MEMORANDUM

SUBJECT: Eagle Farms Wastewater Reuse Permit Application Review -- LA-000207-01
(Industrial Wastewater Facility)

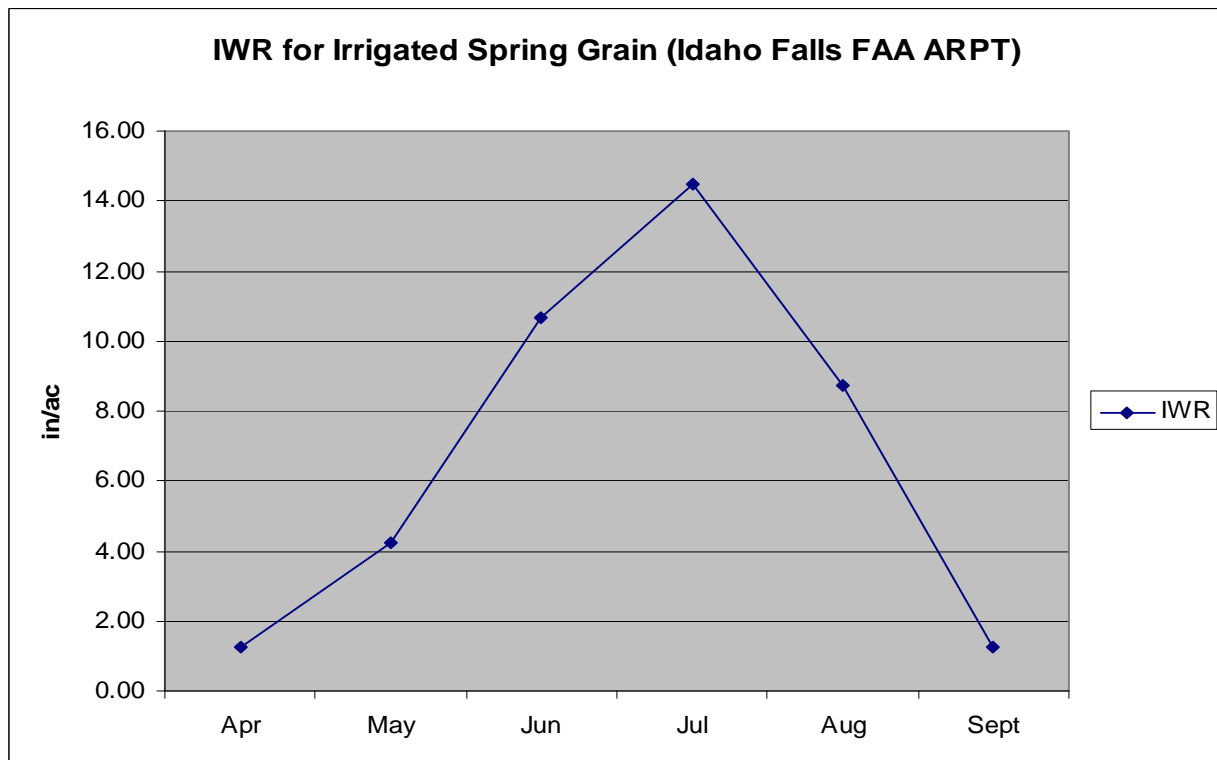
The graph below illustrates the 30 year irrigation water requirement for irrigated spring grain and an assumed 60% irrigation efficiency (Allen, 2007c).

It is recommended that the facility generally adhere to the IWR for the crop in question in order to facilitate both productive crop yield and crop nutrient uptake. If the facility should decide to change crops a new IWR should be calculated. For the full text of this condition see Section F of the permit.
